SERVICE BULLETIN

Product: NF MONITOR
Model: PG17NS, PG19NS
 SyncMaster 700NF, 900NF

Bulletin No.: MON01-007 (00-C/M-E0021)
Bulletin Date: May 10, 2001
ECN Date: May 10, 2001

SUBJECT: Display Shift or Size Change

Cause:

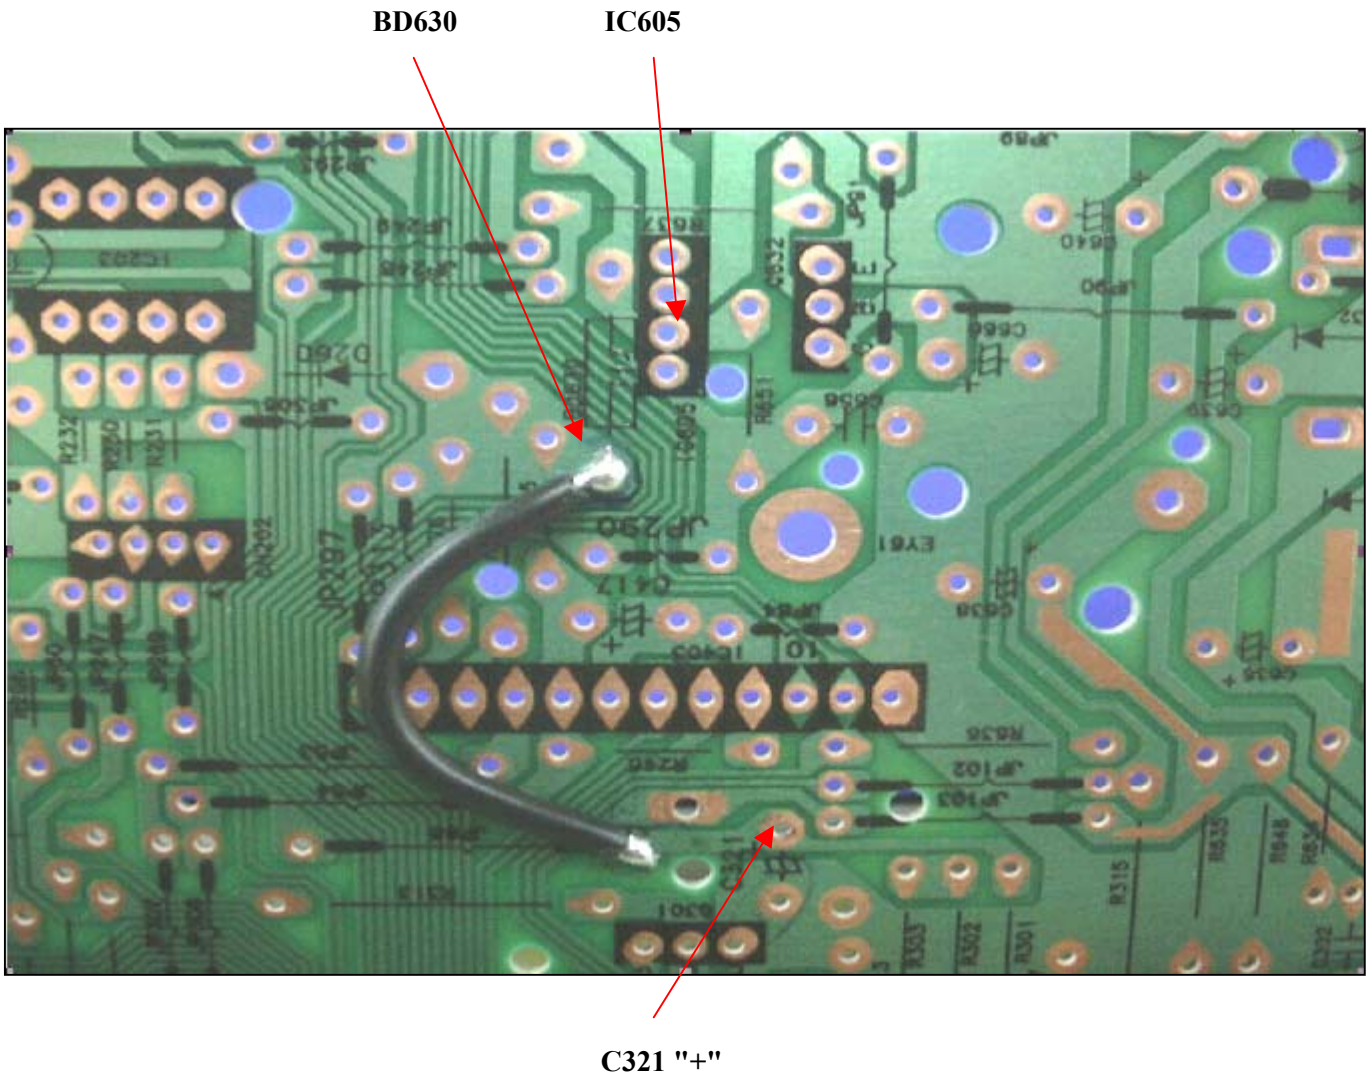
Background: The PG17NS and PG19NS may have symptoms of the vertical position changing and horizontal size increasing.

Solution: To correct the vertical position shift, add a jumper wire from BD630 to C321 “+”. Change the value of R301 from 100k ohm to 220k ohm. Remove jumper wire connecting IC261 #13 and JP68.
 To correct the horizontal size increasing symptom, change the type and tolerance on both R286 and R289 from Carbon 5% to Metal 1%.

R301

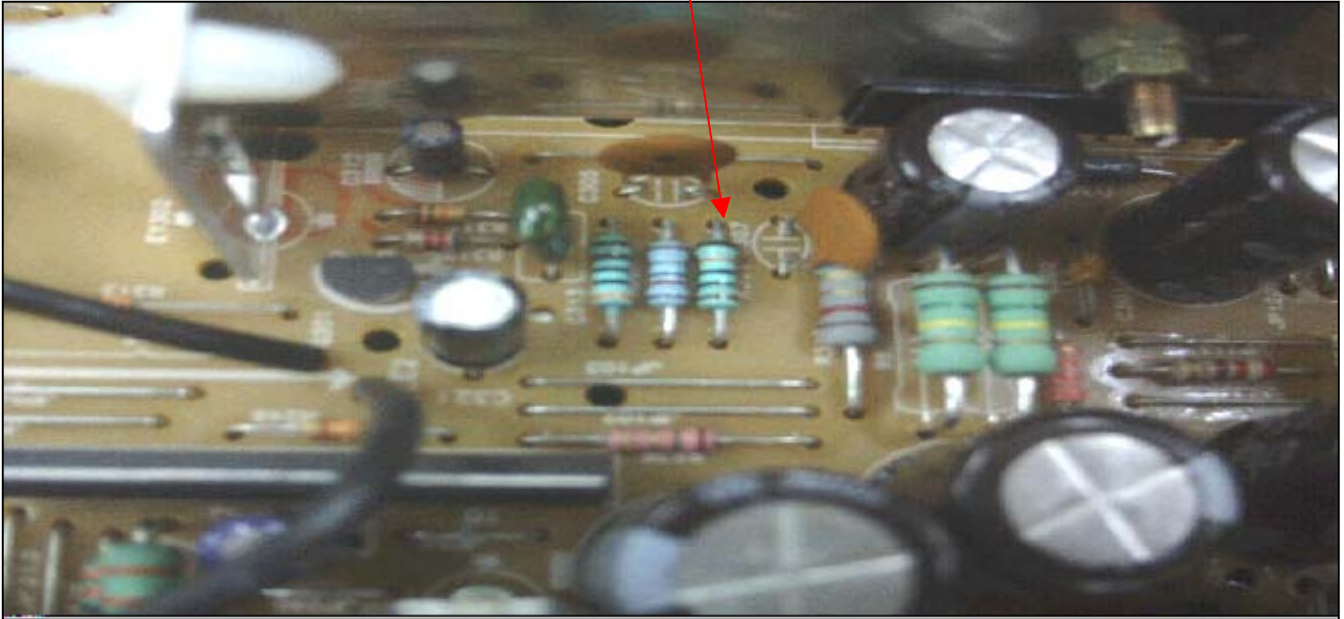
A. Countermeasure for V-position shift

1. Add jump wire on the back side of PCB

2. Replace R301

Remove

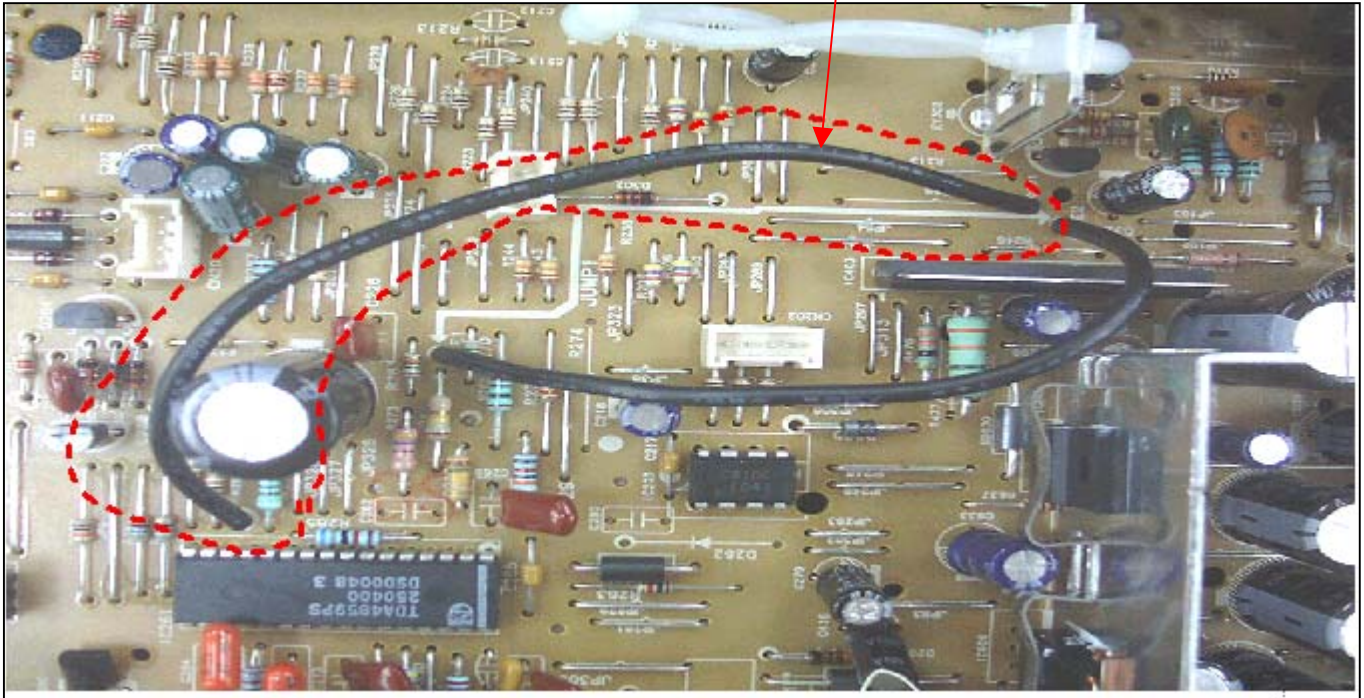
3. Remove jumper wire which connecting IC261 #13(Vref) and JP68

R286 **R289**

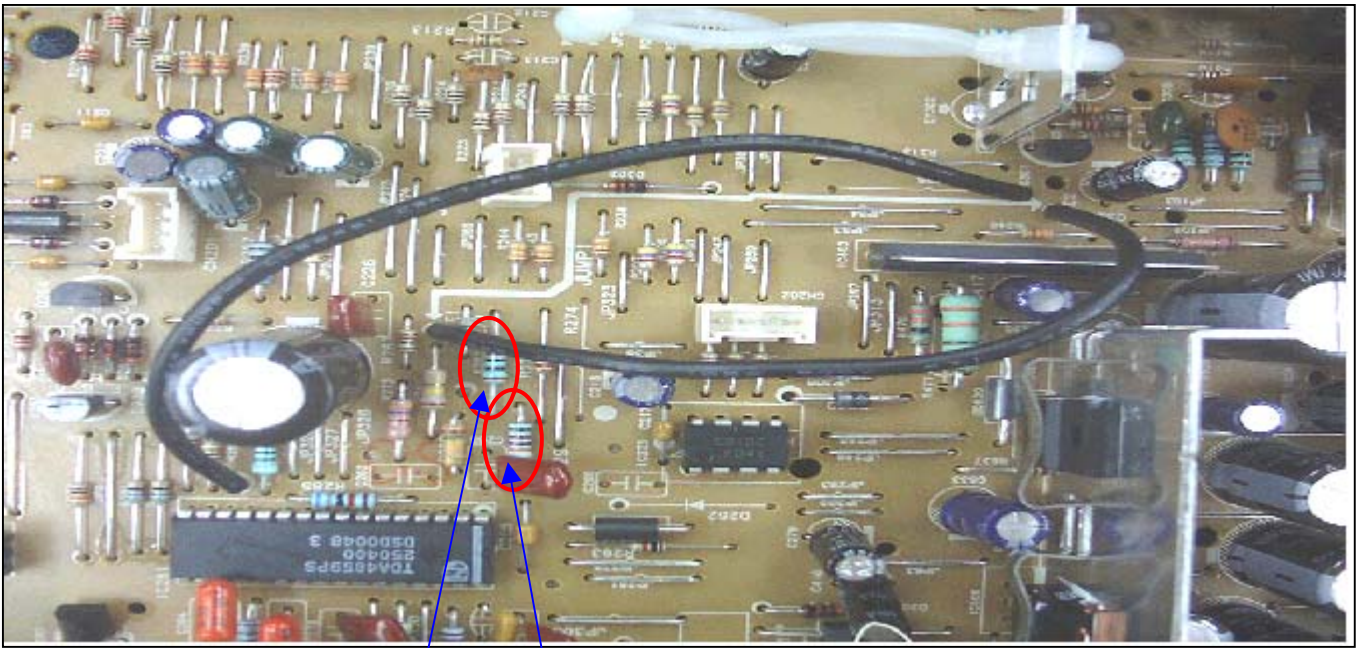
B. Countermeasure for increasing H-size

ORIGINAL			NEW	
Location No.	Part No.	Description	Part No.	Description
R301	2004-000193	R-METAL, 100k, 1%	2004-000560	R-METAL, 220k, 1%
R286	2001-000395	R-CARBON, 180k, 5%	2004-000398	R-METAL, 180k, 1%
R289	2001-000354	R-CARBON, 150k, 5%	2004-000327	R-METAL, 150k, 1%
